Work Order ID 132521

Item Name: Replacement Skidtube (Fits LH or RH)

DRAWING NO. D2650	TITLE 206/407 SKIDTUBE ASSEMBLIES	REV. F	DART AEROSPACE LTD ENGINEERING ORDER		D.E.O. NO. D2650-F-1	SHEET NO. SHEET 1 OF 1	SCALE NTS
DRAWN <i>JP</i>	CHECKED <i>A.P.</i>	MFG. APPR. <i>DA</i>	APPROVED <i>HA</i>		DE APPR. <i>HA</i>		
DATE 12.10.12	DATE 12.10.22	DATE 12.10.22	DATE 12.10.22		DATE 12.10.22

PURPOSE:

DETAIL G

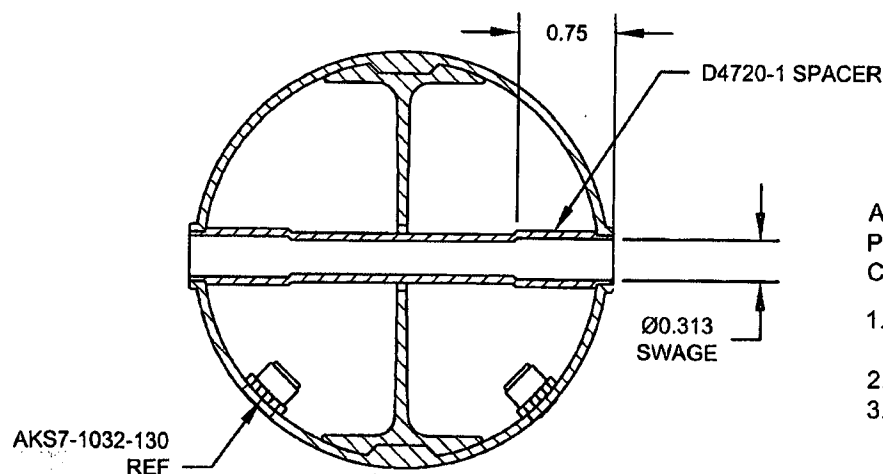
ADD DETAIL G BELOW, WHICH IS THE SAME SECTION VIEW AS DETAIL D OF DWG.
C'BORED HOLES ARE **NOW SWAGED** PER DETAIL G BELOW. FOR THE Ø0.375 HOLE THAT IS NOT C'BORED, WELD PER DETAIL D OF DWG (SEE AMENDED DETAIL B FOR REFERENCE).

AFTER DRILLING AND BENDING ASSEMBLY
PERFORM THE FOLLOWING FOR Ø0.375 HOLES THAT ARE
CURRENTLY C'BORED:

1. INSERT D4720-1 SPACER, 16 PL (-1) OR 17 PL (-3)
OR 19 PL (-5) OR 23 PL (-7)
2. SWAGE TO Ø0.313 X 0.75 DP PER QSI 002
3. TRIM / GRIND FLUSH PER QSI 002

DETAIL B

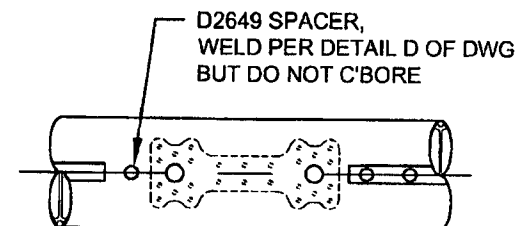
AMENDMENT TO DETAIL B
NOT TO SCALE

FOR Ø0.375 HOLES ONLY
FOR HOLES THAT ARE CURRENTLY C'BORED ONLY
NOT TO SCALE
